RAPID CREEK LANDCARE GROUP INC.

**SUBMISSION TO:
2020/0397 SUBDIVISION**

**SECTION 04106 HUNDRED OF BAGOT
1 BOULTER ROAD, BERRIMAH**

**SUBDIVISION TO CREATE 37 LOTS,
INCLUDING ONE PUBLIC OPEN SPACE LOT**

Pre-development 1% AEP – abstracted from page 32 of the ADG Report

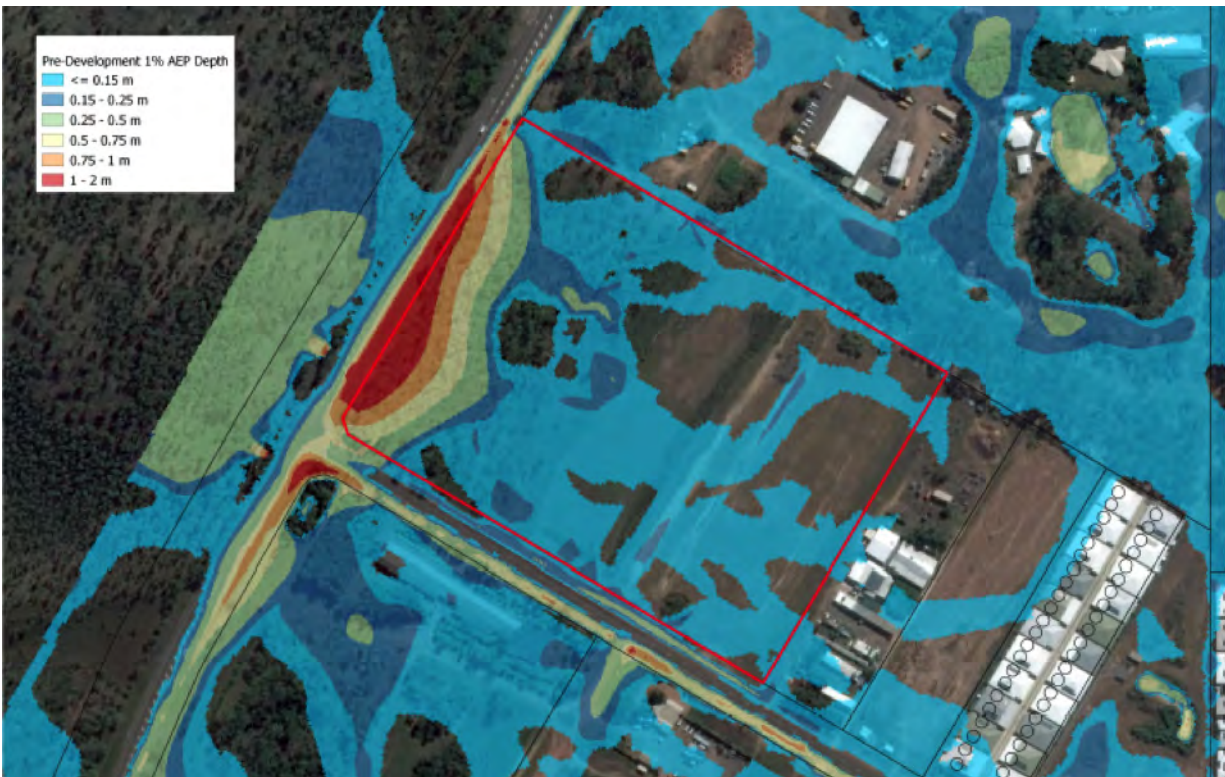
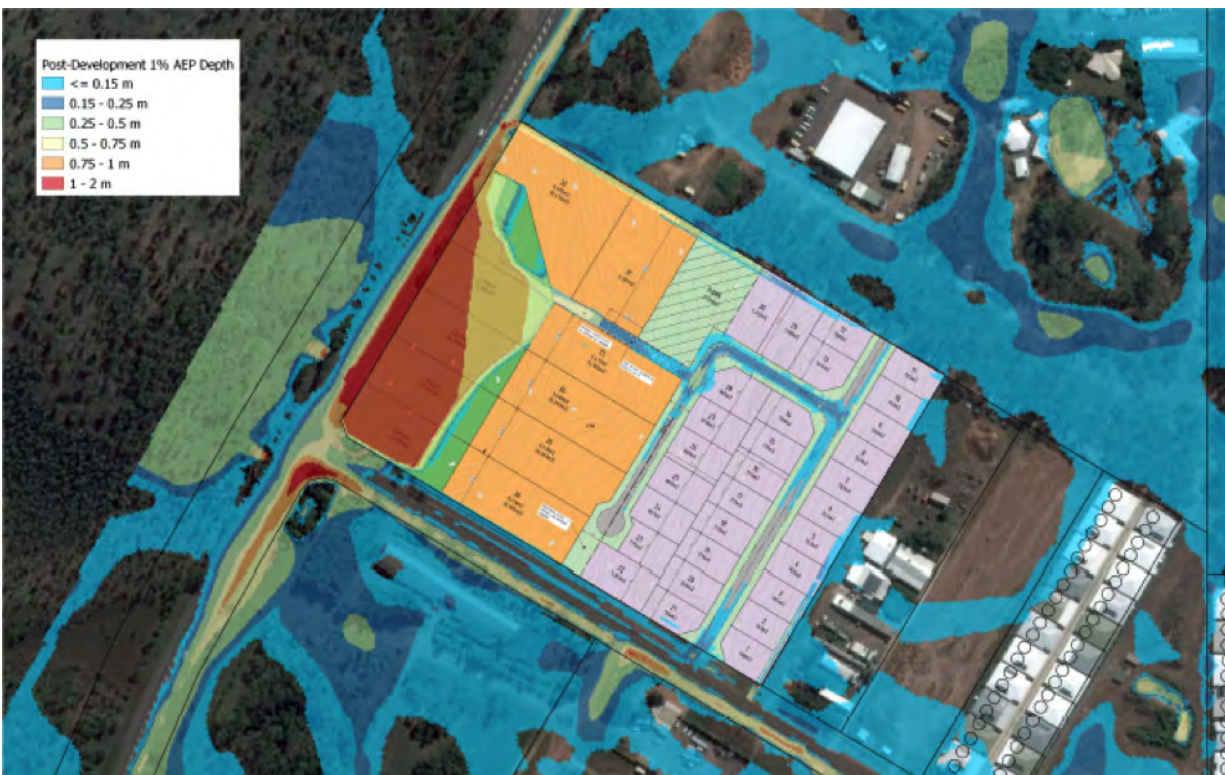
Further, the maps provided in this document on pages 32 to 35 show that the area of the subdivision is subject to flooding from the 1% AEP in the pre-development modelling scenario, but is then miraculously flood free post development, presumably by raising the ground level of the lots, and that has been achieved with a net **decrease** in modelled flood flows. To say that this is totally unbelievable is putting it mildly!
